Appendix B – Submissions Response Table (SSD- 65924461)

Summary of Issue Raised	Response	Relevant Document
Department of Planning, Housing and Infrastructure (DPHI)		
Background		
1. Please provide details on existing site operations including existing hours of operation, traffic numbers and staffing numbers	The site currently operates from 9:30pm Sunday to 9:30pm Friday except for public holidays. There are currently 88 employees on the site. Existing traffic conditions are provided in Section 5 of the updated Traffic Impact Assessment provided at Appendix M .	Appendix M
Urban Design

Figure 2: Office Sections - Extract from Office Section A of Appendix F Architectural Plans
(Source: Architectural Plans, SBA)

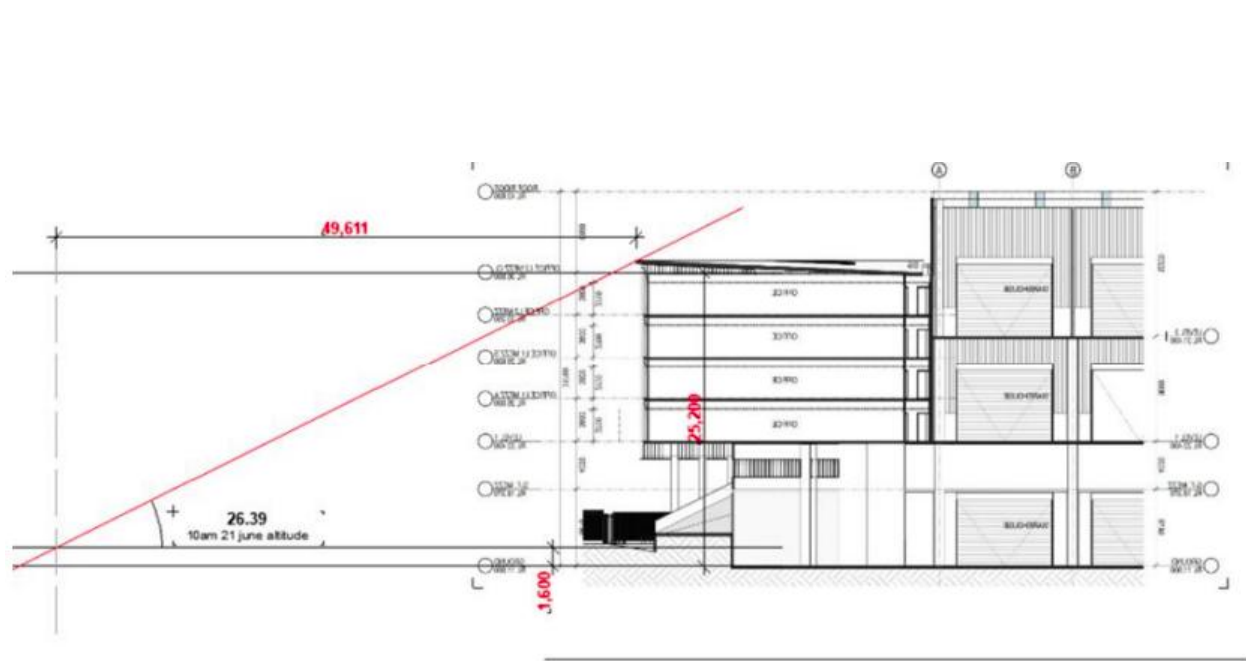
Summary of Issue Raised	Response	Relevant Document
properties and street level. Refer to Figure 1, which is a view from the street in front of No.42A Brighton Street – located 8 metres above the street level of Stephen Road. Viewpoint 6 is the only location judged to be of high/moderate visual impact significance, with the development obscuring existing easterly views for these homes. However, Council staff consider that the other viewpoints, including viewpoints 5, 7, 8, and 9 also have a high visual impact when viewed from residential properties and public domain from various angles. In this regard, the VIA makes assumptions regarding the scale of vegetation growth in the interface between the industrial zone and the R2 zone. The front landscape area slopes down between the street level and the proposed building. This raises concerns about whether the planting will be able to effectively provide screening of the lower parts of the building as shown in the VIA. Given the height of the proposed building, the trees will not adequately screen the built form. In addition, as noted in the Landscape section of this letter, Council raises concern that the dimensions of the landscape setback will not allow the trees to grow optimally and offset the visual impact of the building. A revised VIA must be submitted in response to any design and landscaping changes to accurately assess visual amenity impacts on the public domain and to the residents located along the western side of the site that are affected by the line of sights to the truck ramp towards the south of Stephen Road.	high/moderate to moderate and several other viewpoints have been reduced from moderate or moderate-to-minor and minor or negligible impacts.

Figure 3: Shadow Diagrams – Extract from Page 30 of Appendix I Design Report
(Source: Design Report, SBA)

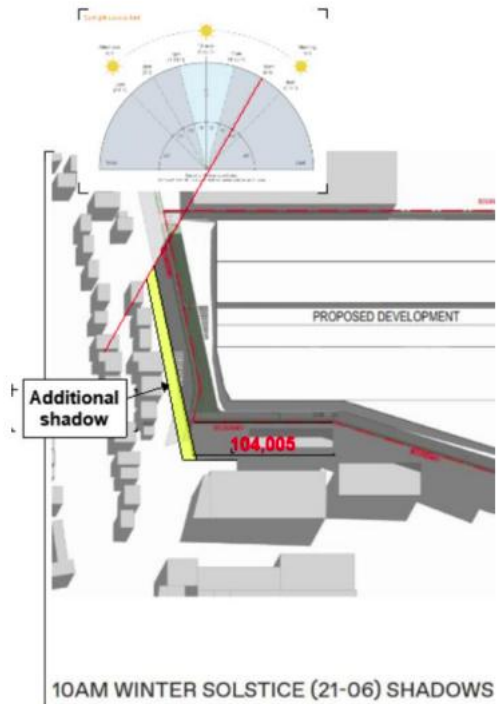
4. <u>Solar Analysis</u> A review of the solar analysis and shadow diagrams provided in the Design Report, prepared by SBA (dated 18 November 2024), appears to show some discrepancies in depicting the extent of shadow cast over Stephen Road. The section in Figure 2 shows the shadow cast at 10AM, mid-winter as being approximately 49.6 metres in length. This is approximately 10 metres longer than the shadow shown on Page 30 of the Design Report (Figure 3). It is also noted that the position of residential dwellings depicted on shadow diagrams are not included in the survey drawing provided. Further information is required to clearly and accurately demonstrate the extent of overshadowing to existing residential dwelling on the western side of Stephen Road.	The revised two-storey design results in significantly less overshadowing impacts than the previous three-storey design. There will be no overshadowing of any dwellings, with a minor intrusion into the private open space along Stephen Road at 9amm which is considered a minor solar impact. New shadow diagrams have been provided in the updated Design Report at Appendix I.	Appendix I
